## **Global Change Notification (GCN)**

Product Family USB A Plug 10666760

Series 67329 January 20, 2015

**Product Component Change**

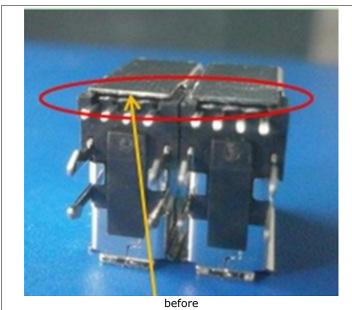
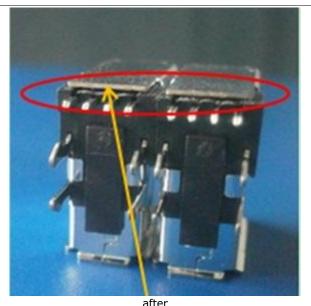
The purpose of this letter is to inform you that we plan to change 67329 USB A Plug plating method from hang plating to reel to reel plating to improve yield in process, the change is targeted to implemented on 2015-02-28. We have done 8h/12h/24h salt spray test for this change and confirmed no impact. the part list is as enclosed.

8h/12h/24h Salt spray test ok.

Add :WORD"C"on the label
